New features

Fusesaver™
medium-voltage
outdoor
circuit breaker

Rechargeable Communications Module (RCM)

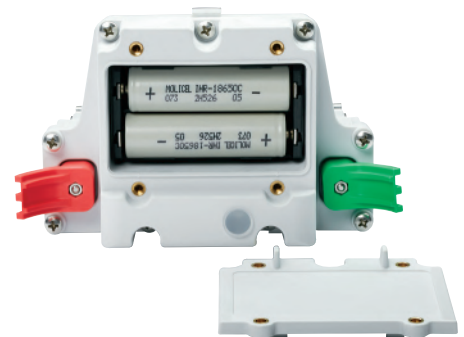
Introducing a new communications module including a rechargeable battery and a new set of features:

- Cold load pickup
- Improved protection element-setting options
- Configurable fault-passage indication
- Configurable manual-trip delay
- Better display of event log fault data
- Security upgrades and performance stability enhancements.

A new version of the communications module with a rechargeable Lithium-Ion battery is now available.

The battery can provide backup power for up to 10 days* and is recharged from even the minimum line current to self-power the Fusesaver. If the line has no current for 24 hours, it will take 24 hours to recharge the Fusesaver with minimum line current. When required, the battery can be easily removed and exchanged via the access panel.

The new rechargeable communications module is suitable for all legacy Fusesavers once updated with the firmware of this release.
